**Item 4.****Development Application: 171B Botany Road, Waterloo - D/2022/79**

File No.: D/2022/79

**Summary**

**Figure 29:** Height plane diagram with areas over the height limit identified in blue and areas under the height limit identified in green

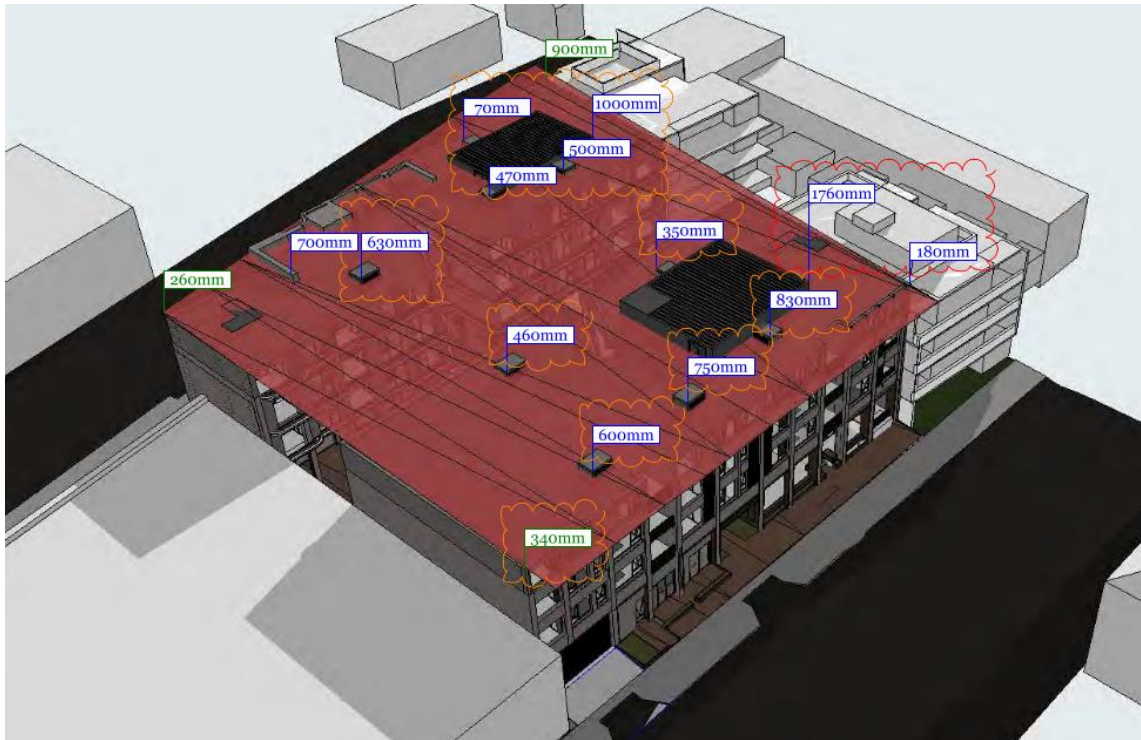
68. The site is subject to a maximum height of buildings control of 15m. The proposed development has a maximum building height of 16.76m equating to a variation of 11.7%. The figure below shows the elements of the proposed building that breach the height limit. These elements are lift overruns, plant, building parapets and clerestory windows.

69. A written request has been submitted to Council in accordance with Clause 4.6(3)(a) and (b) of the Sydney LEP 2012 seeking to justify the contravention of the development standard by demonstrating:
- a. That compliance with the development standard is unreasonable or unnecessary in the circumstances of the case;
  - b. That there are sufficient environmental planning grounds to justify contravening the standard;
  - c. The proposed development will be consistent with the objectives of the zone; and
  - d. The proposed development will be consistent with the objectives of the standard.
